SAN FRANCISCO PLANNING DEPARTMENT

Executive Summary Amendment to Design for Development

Date: June 6, 2013
Case No.: **2013.0196U**
Project Address: **Hunters Point Shipyard Phase I**
Zoning: HPS Redevelopment Project Area
Block/Lot: 4591C / 001-211
4591D/ 001-143
Project Sponsor: Thor Kaslofsky
Office of Community Investment and Infrastructure (OCII)
(Successor to the Redevelopment Agency)
One South Van Ness
San Francisco, CA 94103
Staff Contact: Mat Snyder – (415) 575-6891
mathew.snyder@sfgov.org
Recommendation: **Approval**

Hunters Point Shipyard
Figure 1

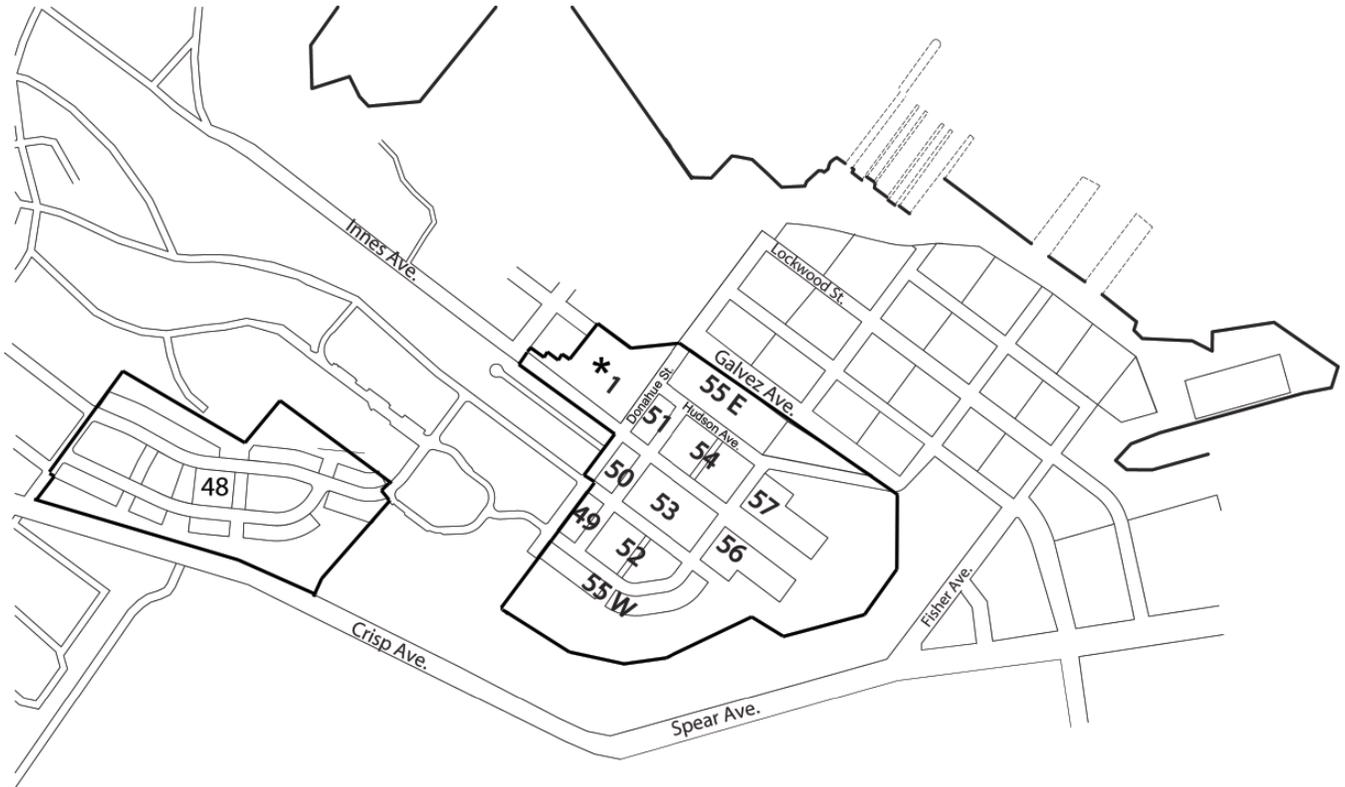
Legend and note added.

Hunters Point Shipyard
Figure 9

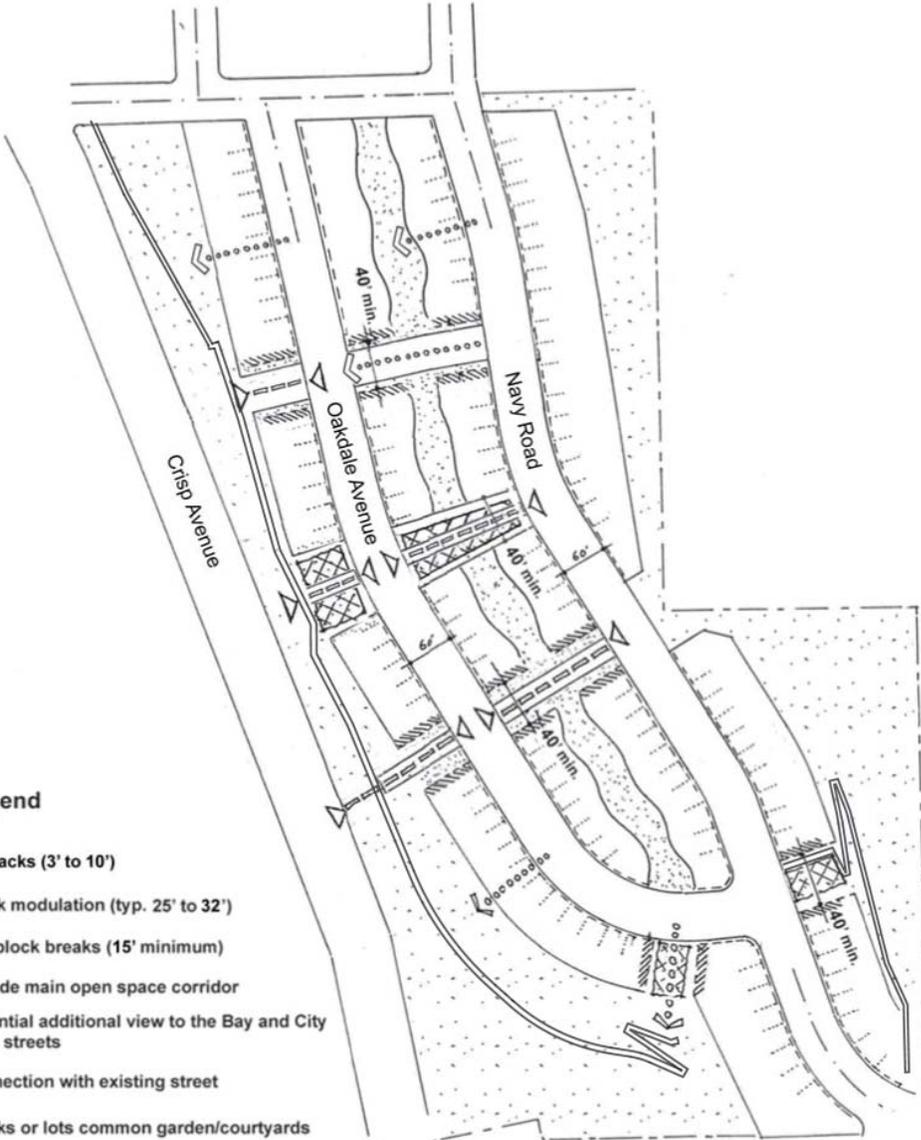
BLOCK 48 - Block number added
